P.O.A.D.P. PLAN for MACKAY RANCH

Re: Mackay Ranch POADP # 570

The City Staff Development Review Committee has reviewed Mackay Ranch Subdivision Preliminary Overall Area Development Plan # 570. Please find enclosed a signed copy for your files. Although your plan was accepted, please note the following:

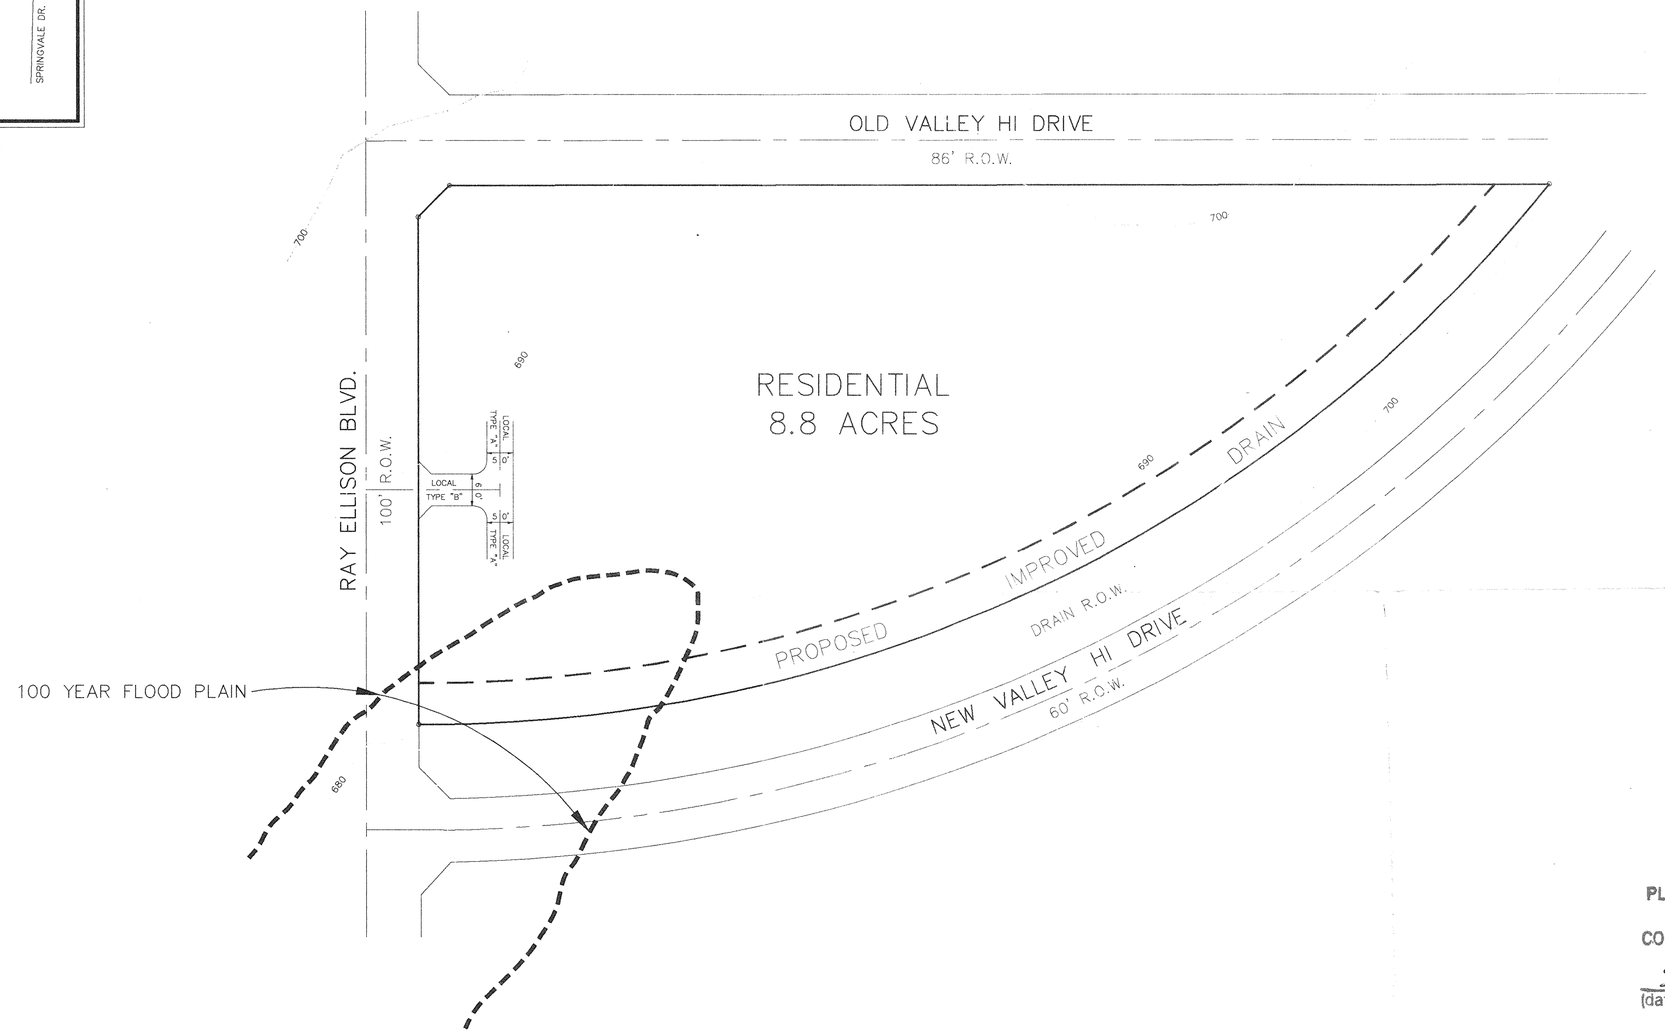
- Based on the topography, a Flood Plain Study and drainage review will probably be required during the platting process.

- This development will need to comply with tree preservation ordinance #85262. For additional information about these requirements you can contact Building Inspections at 207-7102.

Comments: Flood plain requirements and drainage easements will be require and will be address during the platting process.
